STATE OF NORTH CAROLINA
DEPARTMENT OF TRANSPORTATION

Subject: Modification Request for the Individual Section 404 Permit, Individual Water Quality Certification, and Tar-Pamilico Buffer Authorization for the Rocky Mount Northern Connector, from SR 1604 (Hunter Hill Road) to US 301, Nash County, TIP No. R-2823, Debit \$570 from WBS 34509.1.1.

In an application dated December 17, 2008, the North Carolina Department of Transportation (NCDOT) submitted an Individual Permit application for the Subject project. This application requested authorization for impacts to jurisdictional features based upon a final design prior to an additional public meeting presenting the final design, held on October 28, 2008. Based upon comments from the meeting and subsequent inquiries from the public concerning the traffic flow from Station -L- 27+45 to Station 65+55, the roadway was re-designed to include directional crossovers and four bulb U-turns to provide additional left-turn traffic flow along Woodruff Road. The redesign will result in unavoidable impacts to Waters of the U.S. Revised permit drawings, buffer drawings and roadway plans are included with this modification request.

PROJECT REFERENCE NO.	SHEET NO.
R-2823	17
RW SHEET NO.	
ROADWAY DESIGN ENGINEER	HYDRAULICS ENGINEER
REVISED 06/1/09 PERMIT DRAWING SHEET 43 OF 68

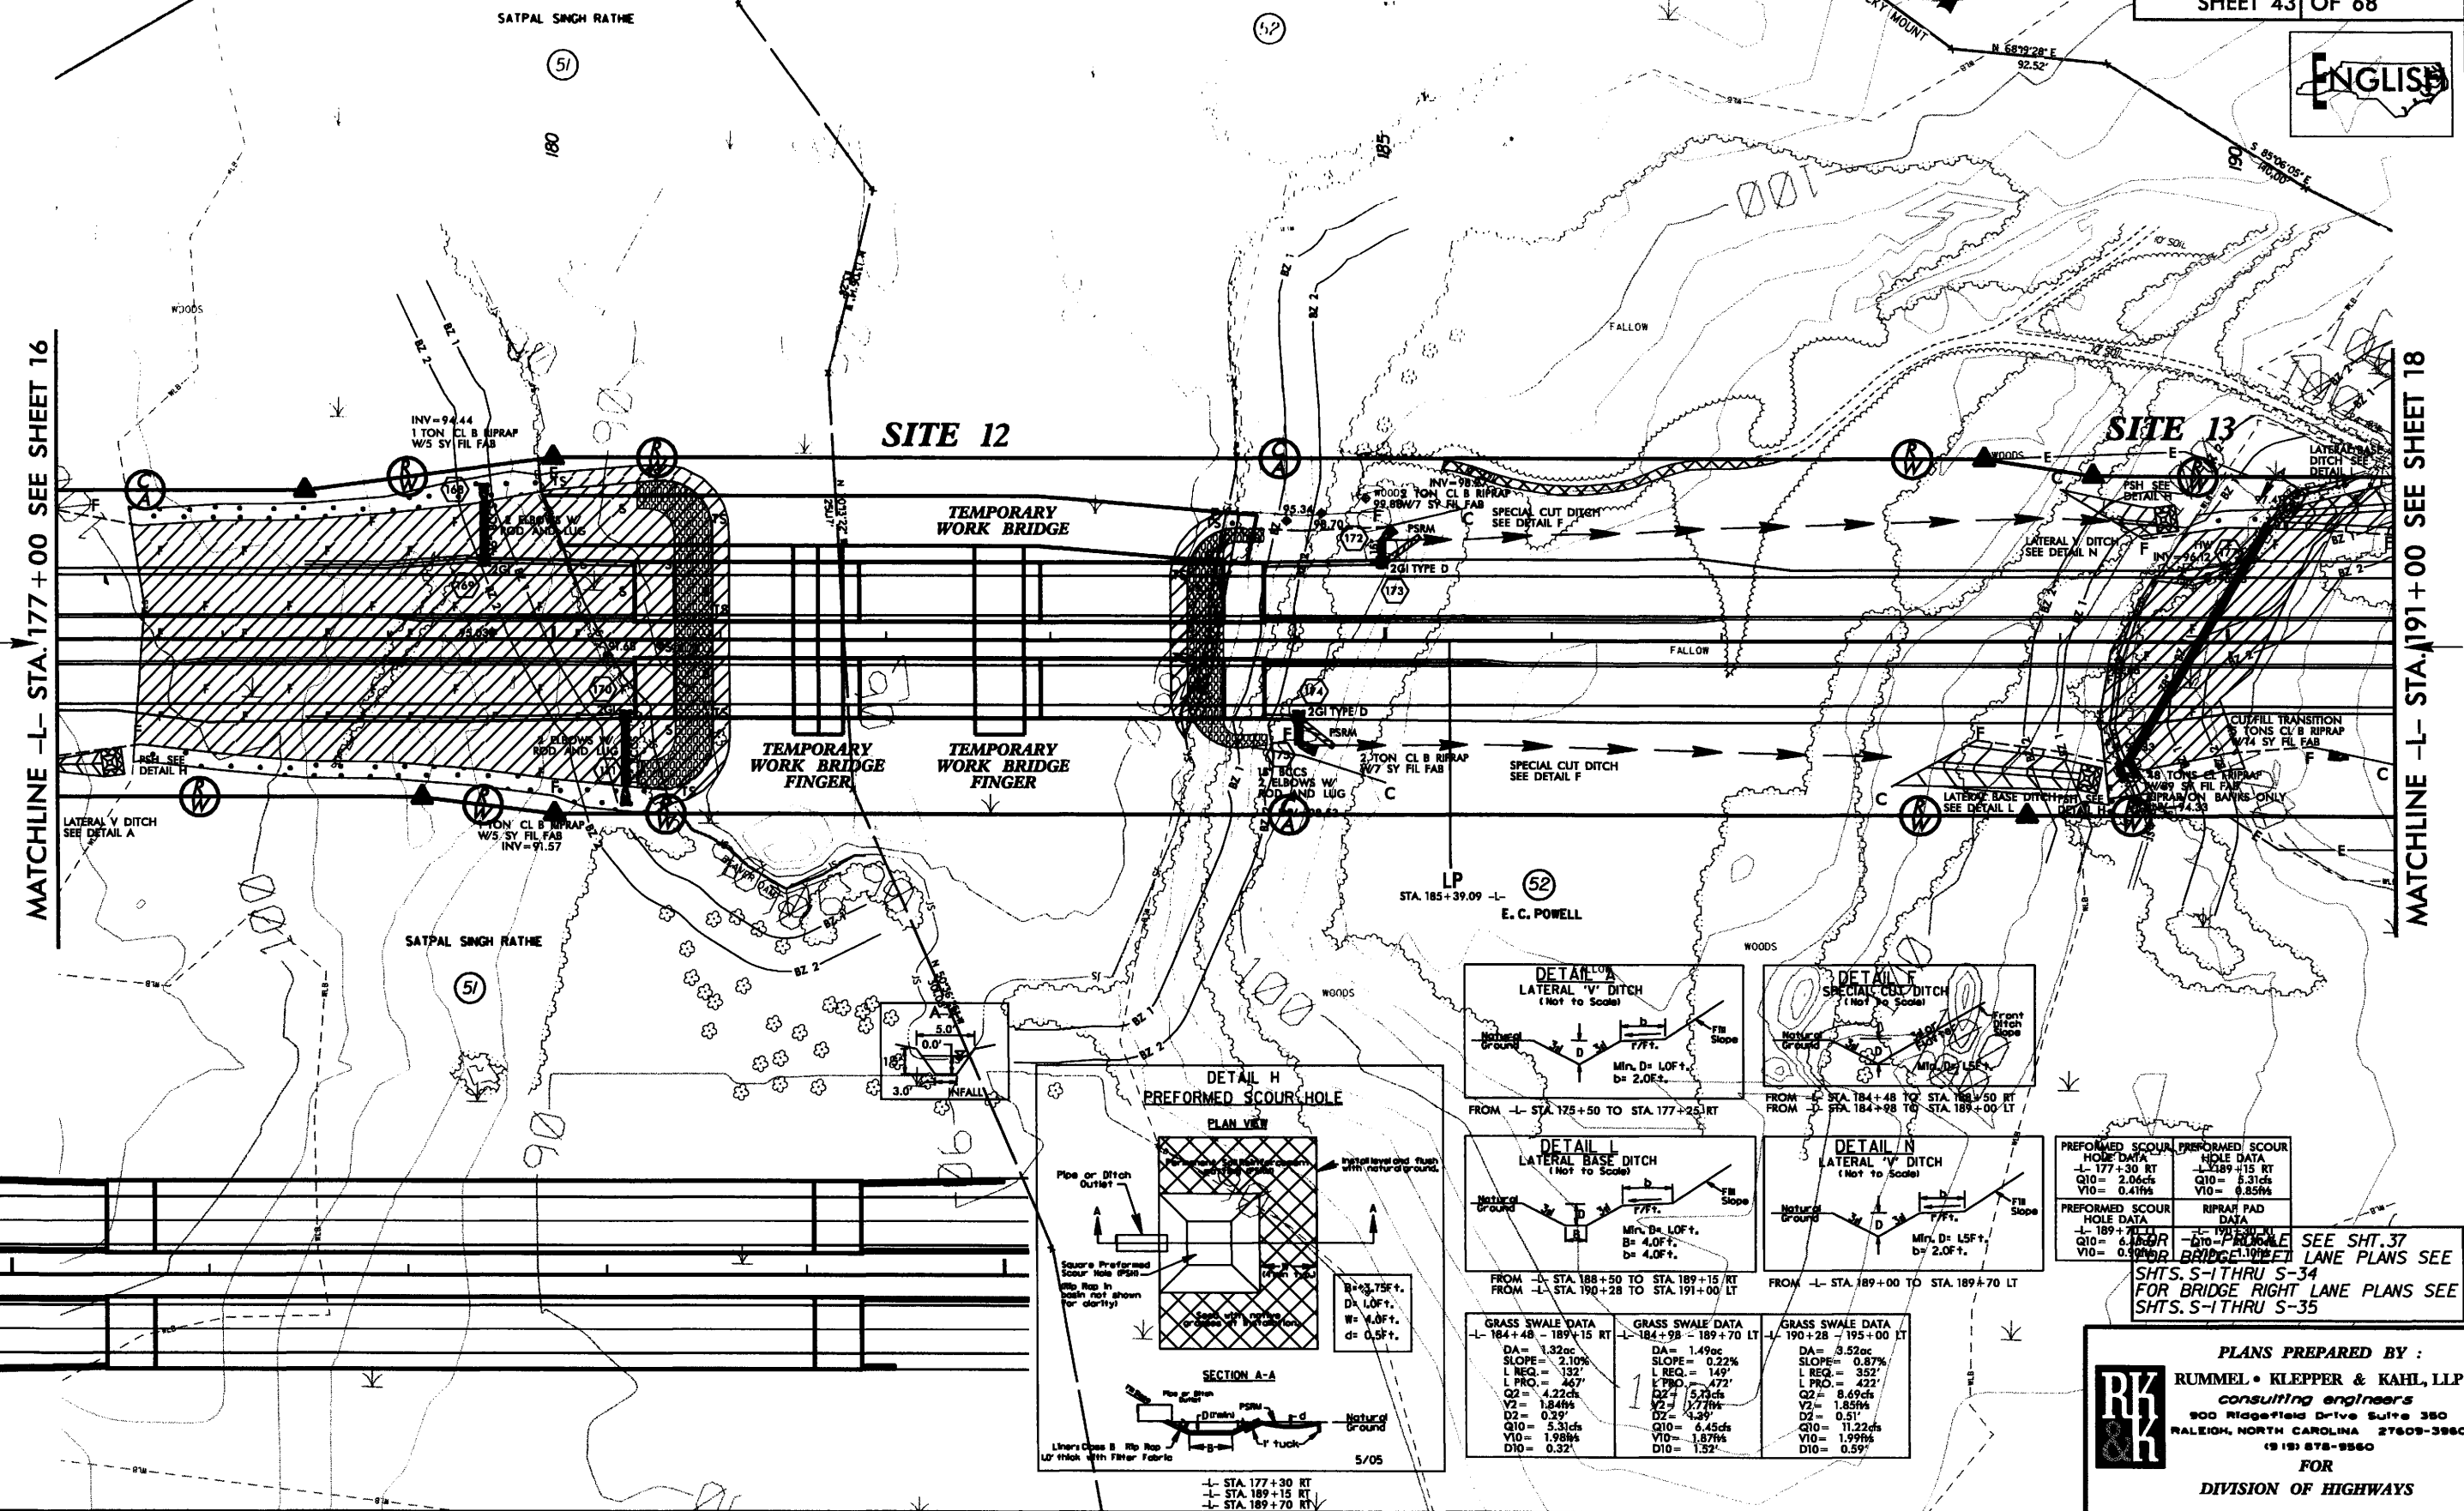
The revised drawings (Permit Sheets 43 and 44 of 68 and Buffer Sheets 34 - 37 of 56) indicate that impacts at Site 13 will change due to a pipe clearance profile change. The profile was modified slightly at 189+90 to increase the amount of fill on top of the pipe to reduce possible maintenance issues for the pipe and road in the future. A summary of the original and revised impacts is provided in the following table.

Impact Description	Dec. 17, 2008 Impact	Revised Impact	Impact Change
Fill in Wetlands	0.21 Ac	0.26 Ac	+0.05 Ac
Excavation in Wetlands	0.02 Ac	0.02 Ac	None
Mech. Clearing in Wetlands	0.06 Ac	0.05 Ac	-0.01 Ac
Perm. Surface Water Impacts	0.01 Ac (205 LF)	0.02 Ac (218 LF)	+13 LF
Temp. Surface Water Impacts	0.00 Ac (43 LF)	0.01 Ac (75 LF)	+32 LF
Wetlands in Buffer Zone 1	9,708 sq ft	10,132 sq ft	+424 sq ft
Wetlands in Buffer Zone 2	2,521 sq ft	2,661 sq ft	+140 sq ft
Mitigable Buffer Zone 1	15,653 sq ft	16,082 sq ft	+429 sq ft
Mitigable Buffer Zone 2	10,114 sq ft	10,345 sq ft	+231 sq ft

SITE 13
REVISED 06/11/09
PERMIT DRAWING
SHEET 51 OF 68

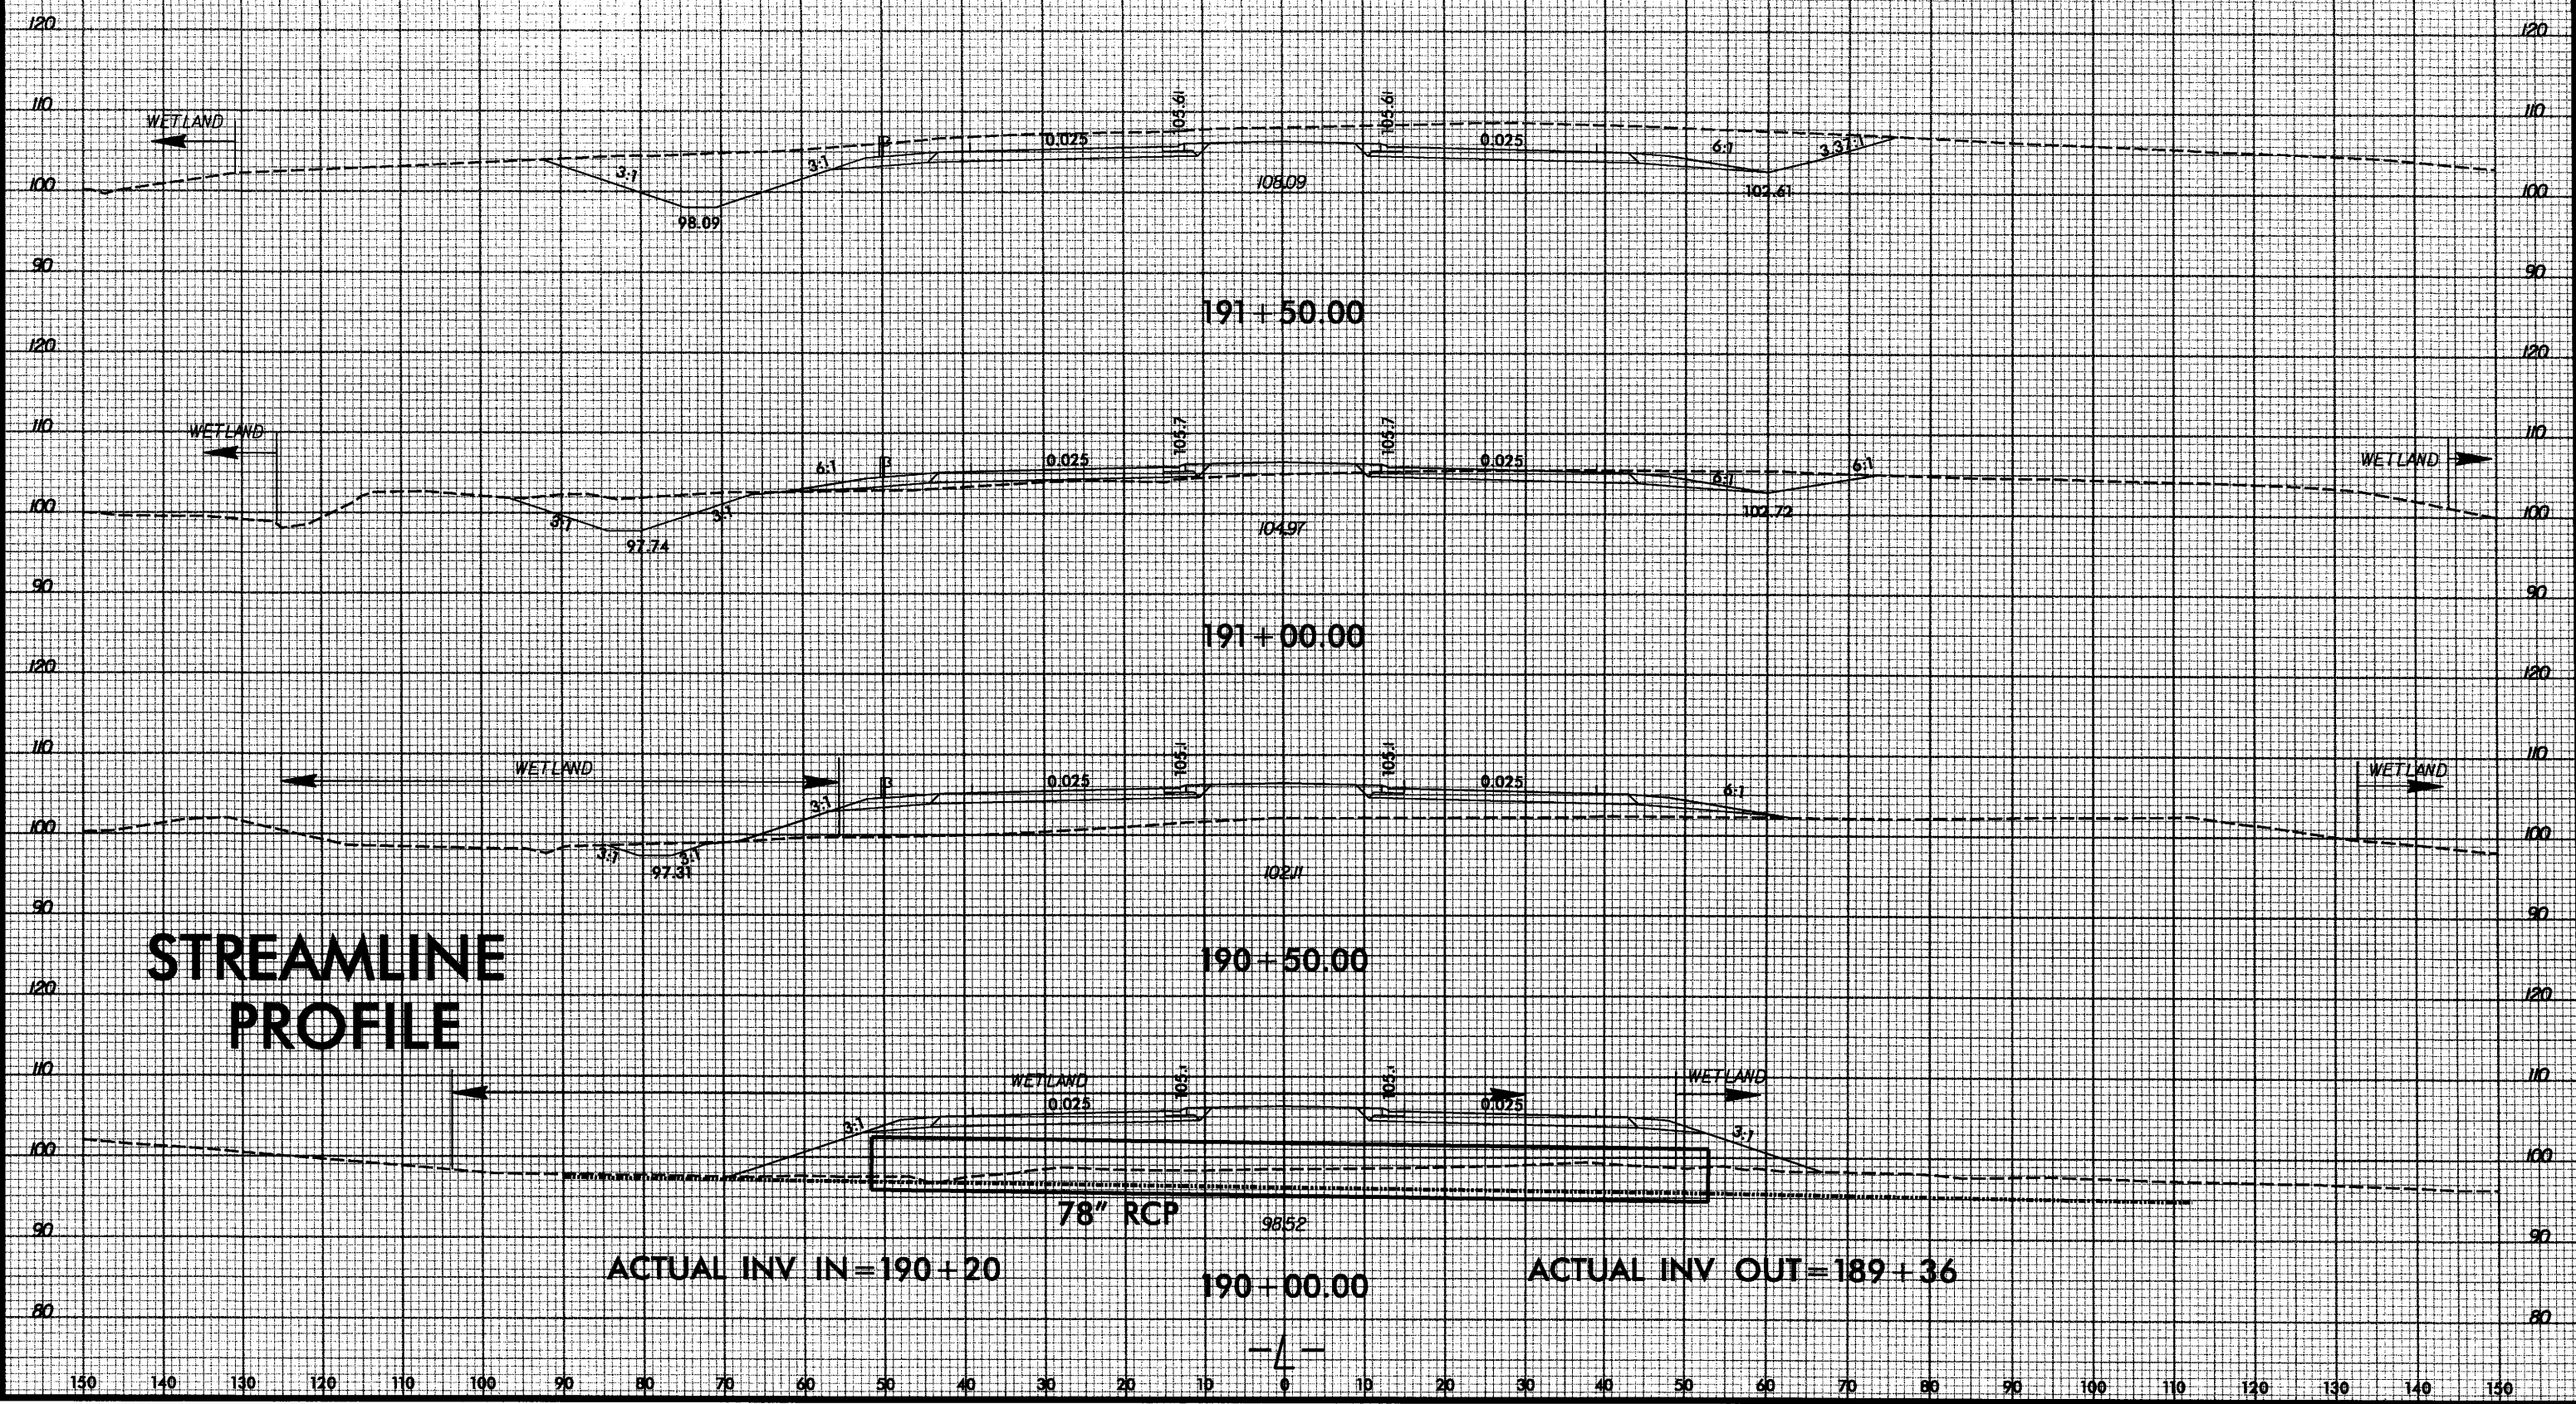
Revised profile and cross section permit sheets 45, 50 and 51 of 68 (buffer sheets 38, 43 and 44 of 56) are enclosed.
